Access Compliance Report

Public Rights-of-Way

(Curb Ramps)

Intersection ID: N/A	Main Street: N COLLEGE ST	Cross Street: E 7TH ST	Location: W
ADA ID: 5DF8CD40D0E7	Ramp Type: PerpDiag	Initial Pass/Fail: Fail	Overall Compliance: No
		Severity Score: 12.5

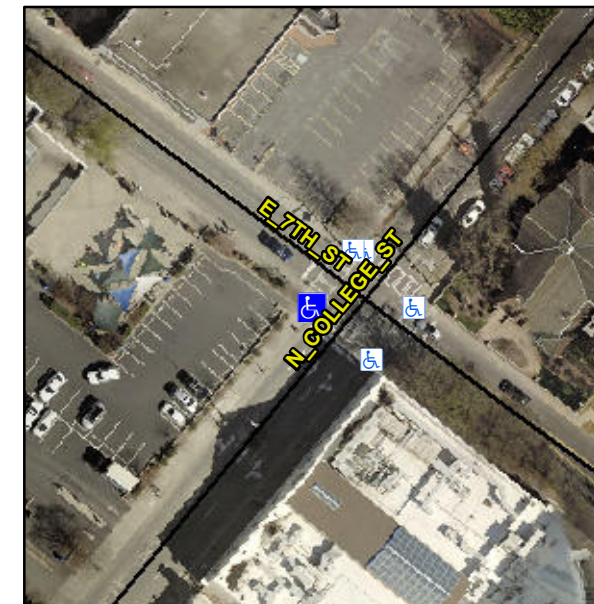
Not Found, R304.2.2

Compliance	Description	Data	Compliance	Description	Data
N/A	Ramp Length (in)	51.0	No	Ramp Slope (%)	8.7
Yes	Ramp Width (in)	93.0	Yes	Ramp XSlope (%)	0.6
N/A	Flare Type LT	N/A	N/A	Flare Type RT	N/A
N/A	Flare Slope LT (%)	N/A	N/A	Flare Slope RT (%)	N/A
N/A	Flare Traversable LT?	No	N/A	Flare Traversable RT?	No
N/A	Landing Length (in)	N/A	N/A	DWS Provided?	N/A
N/A	Landing Width (in)	N/A	N/A	DWS Contrast?	N/A
N/A	Landing Slope (%)	N/A	N/A	DWS Length (in)	N/A
N/A	Landing X Slope (%)	N/A	N/A	DWS Full Width?	N/A
N/A	Landing Curb? (Y/N)	N/A	N/A	DWS Offset (in)	N/A
N/A	Shared Landing?	N/A			
N/A	Gutter Ponding?	N/A	N/A	Gutter Slope (%)	N/A
N/A	Gutter Lip Ht (in)	N/A	N/A	Gutter X Slope (%)	N/A
N/A	Painted X Walk1?	Yes	N/A	Painted X Walk2?	Yes
	X Walk 1 Direction	To SE		X Walk 2 Direction	To NE
N/A	X Walk 1 Width (in)	108.0	N/A	X Walk 2 Width (in)	113.0
	X Walk 1 Slope (%)	4.9		X Walk 2 Slope (%)	0.5
	X Walk 1 X Slope (%)	1.5		X Walk 2 X Slope (%)	0.6

Remove & Replace Curb Ramp With Two New Directional Ramps or Equivalent.
